MONTGOMERY COUNTY HISTORIC PRESERVATION COMMISSION STAFF REPORT

Address: 2500 Holman Avenue, Silver Spring Meeting Date: 6/25/2025

Proposal: Construction of two new single-family houses with associated grading, hardscape

STAFF RECOMMENDATION

Figure 8: Proposed site plan submitted for the third preliminary consultation review.

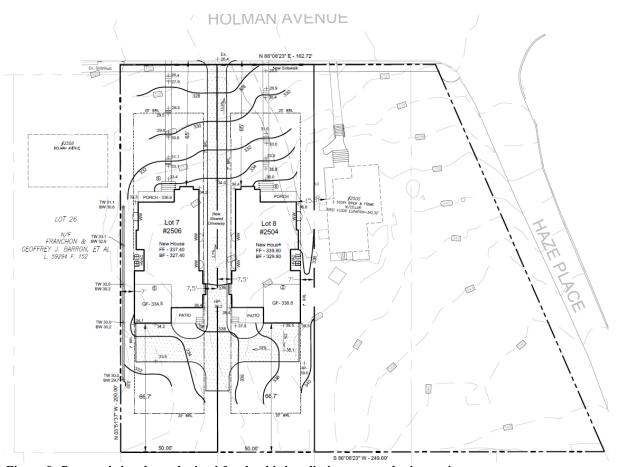
- Revised to show a building width of 31 feet for the first 42 feet, widening to 35 feet for the remaining length of the houses, which have been lengthened from 64 feet to 67 feet 10 inches.

- Revised the distance between the historic house and proposed house on Lot 8 to 15 feet, an increase of 1 foot.
- Lowered the ridgeline by approximately 10 inches from 33 feet to 32 feet 2-7/8 inches from the first-floor level to the ridge. The proposed height from average grade is 36 feet 8 3/8 inches.

- Revised the proposed façade design to incorporate double gable fronts and wall dormers and eliminated the pedimented porch elements. They have also added additional changes in plane and materials to the side elevations.

- Rotated the room orientation but otherwise have not modified the overall building square footage.
- Added zoning information and confirmed that they are within the infill lot coverage requirements.

Figure 12: Section details of the proposed Marvin Essential windows (left) versus the Marvin Elevate windows (right). Staff finds that the Marvin Essential line is extremely flat and does not have the traditional putty slope glazing appearance of the Marvin Elevate line.

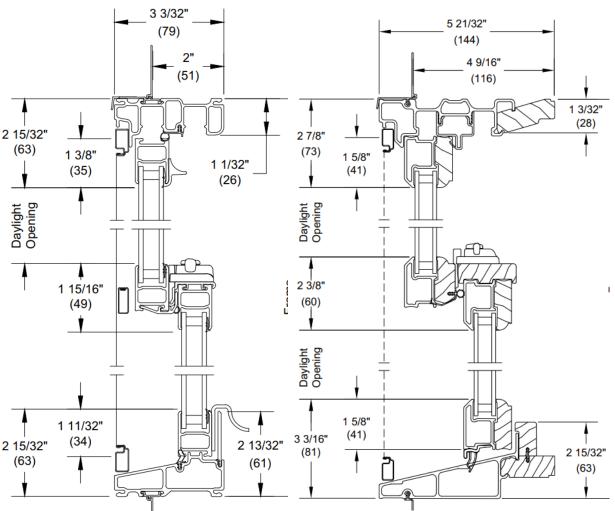
Staff finds that the foundation material change from stone to red brick is consistent and compatible with the district, per Chapter 24A-8(b)(2), as are the proposed Hardie Plank siding and asphalt shingle roofs. Staff continues to find, however, that the proposed Hardie Shake siding proposed on 2506 Holman, which has a .25-inch depth, is overly flat and incompatible in appearance with the historic district, per Chapter 24A-8(b)(2), and recommends that a fiber cement or composite shake siding with a minimum .5-inch depth be utilized. Likewise, Staff finds that the proposed Marvin Essential fiberglass windows, like the previously-proposed Andersen 100 series windows, are overly flat, as can be seen in *Figure 12*, lacking the putty glaze depth of traditional wood windows, and are only available with grilles-between-glass, both details of which Staff finds incompatible for use in a historic district, per Chapter 24A-8(b)(2). Staff recommends the applicants select a more compatible window line with traditional profiles and simulated-divided-lights, such as: Marvin Elevate or Ultimate series; Pella Lifestyle or Reserve series; Jeld-Wen Siteline or W-5500 series; or Kolbe Ultra or Heritage series. The simulated-divide-light windows should

have 1-1/8 to 1-1/4-inch wide putty slope or beaded muntins, in keeping with the dimensions and proportions of traditional two-over-two divided light windows, per Chapter 24A-8(b)(2) and *Standard* 9.

- 1. The Marvin Essential line windows are not approved. The new windows must have a traditional sash to glazing profile and simulated-divided-lights with 1-1/8 to 1-1/4 inch putty slope or beaded muntins; no grilles-between-glass. The applicant must provide window specifications, including the proposed muntin detail.
- 2. The proposed Hardie Shingle siding is not approved. The applicant must submit a specification for a different fiber cement shingle product at least half an inch thick.
- 3. All standing-seam metal roofing is removed and replaced with asphalt shingles.
- 4. The applicant must plant a minimum of two new shade trees per property.
